DESCRIPTION: U-I HI VOLTAGE XFR INSTR. 7834

# TRANSFORMER & COIL ENGINEERING CHANGE NOTICE

| TEKTRONIX PART NUMBER<br>120-1065-00    | ENG P/N-Rev<br>74-65X | PROJECT NO.<br>004690 | INSTRUMENT<br>7834 | BY:<br>JUDY WOODFALL |
| DESCRIPTION TRANSF, PWR, SON & SD (HV.) |                       |                       |                    | DATE 25 JUNE 76      |

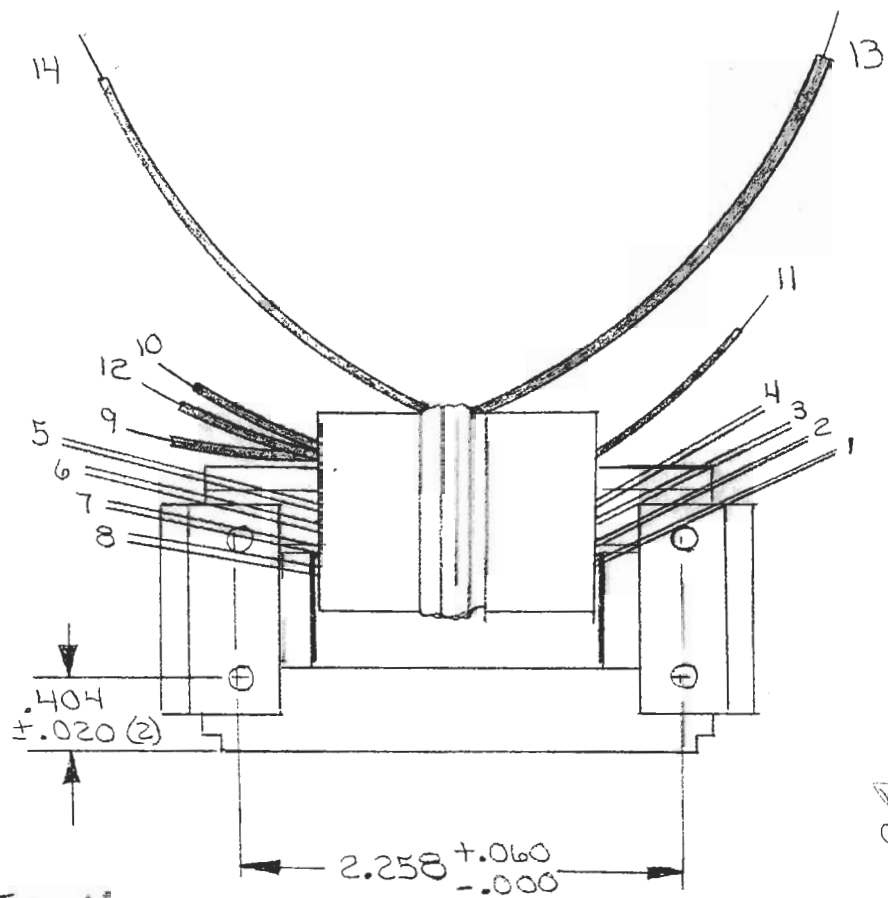
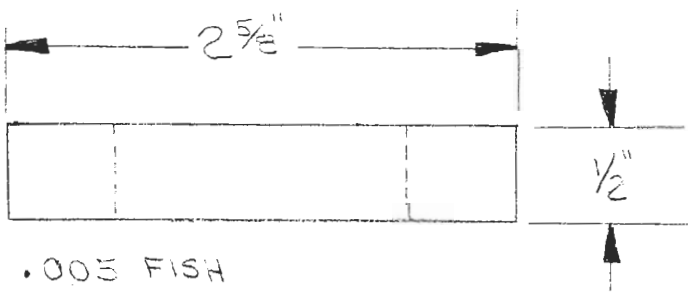
② REPOSITION BRACKETS ON CORE.

③ USE EPOXY FOR CORES AND CLAMPS INSTEAD OF PERMA BOND.

- ① #41 AWG GE#2 IS NOT READILY AVAILABLE SO WOULD BE EXPENSIVE.
- ② REQUESTED BY XFMR PRODUCTION SO PRESENT FIXTURES CAN BE USED.

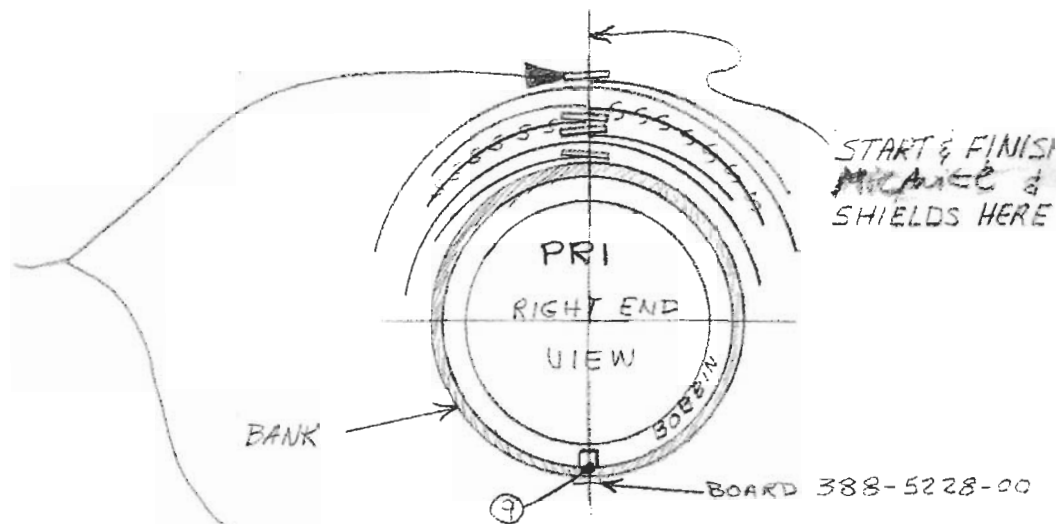
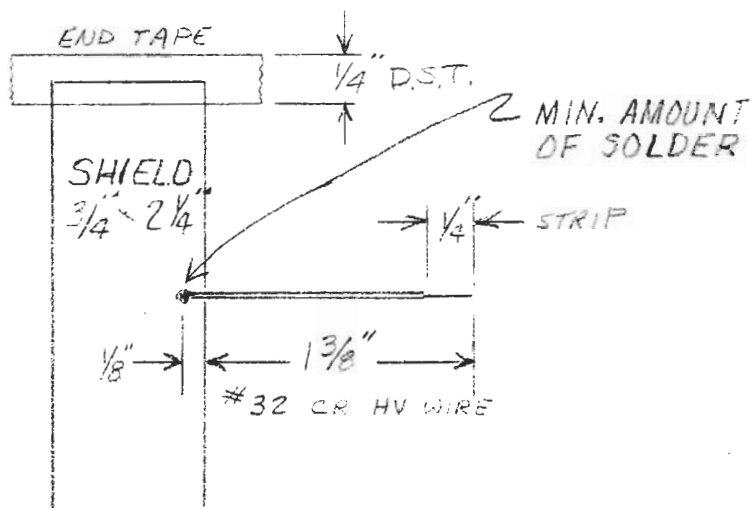
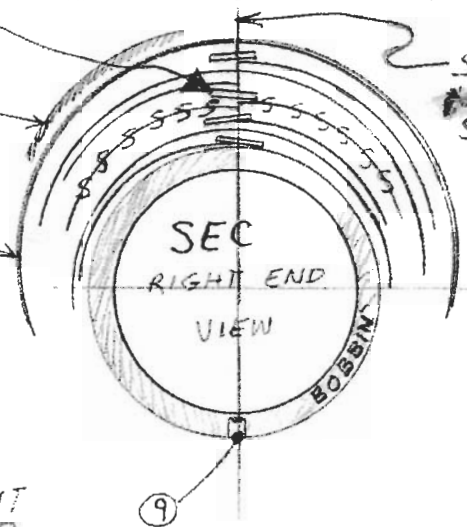
| <p><u>CHANGE</u></p> <p style="font-size: 1.2em; margin-top: 20px;"><i>ADD 1 TURN 3/16" TOLYKEN TAPE OVER THE MICANITE AT EACH END OF COIL BOBBIN. THIS SHOULD HAVE DOUBLE THICKNESS AT THE LAP JOINT WHERE THE MICANITE ENDS.</i></p> |             |                               |                           | APPROVED BY:                        |

74-65XA - 120-1065-

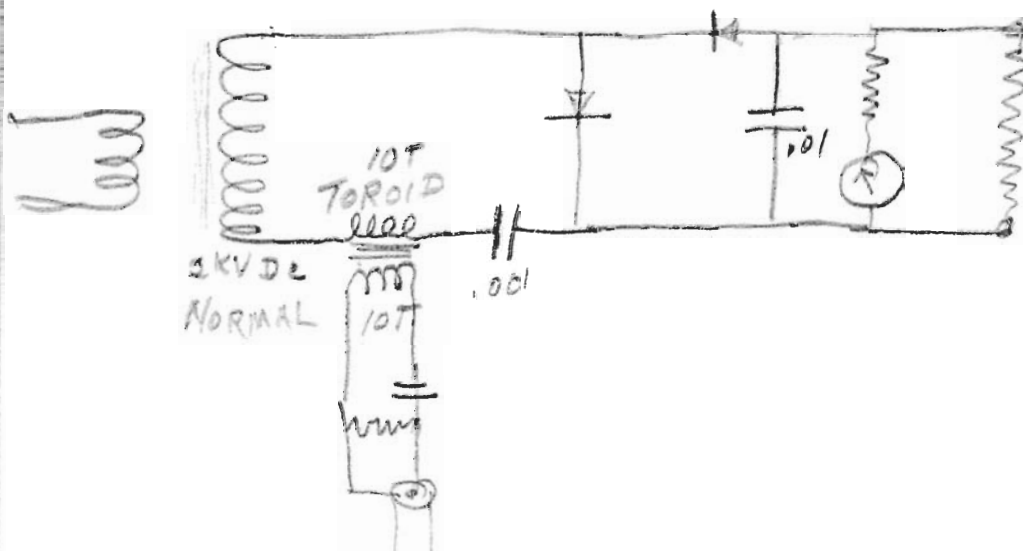
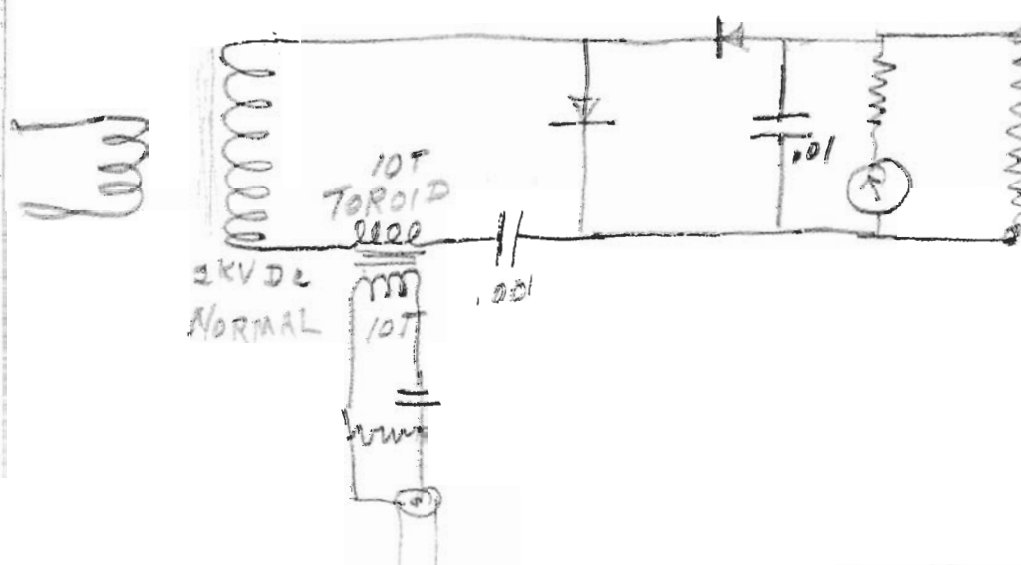
S0535 - 5 mill (micanite) substitute

3 Transformers made and tested

#1 operation OK @ 5KVDC and 39K Feet

#2 operation still good at 39K Feet 5KVDC

#3 operation OK @ 5KVDC and 39K FEET
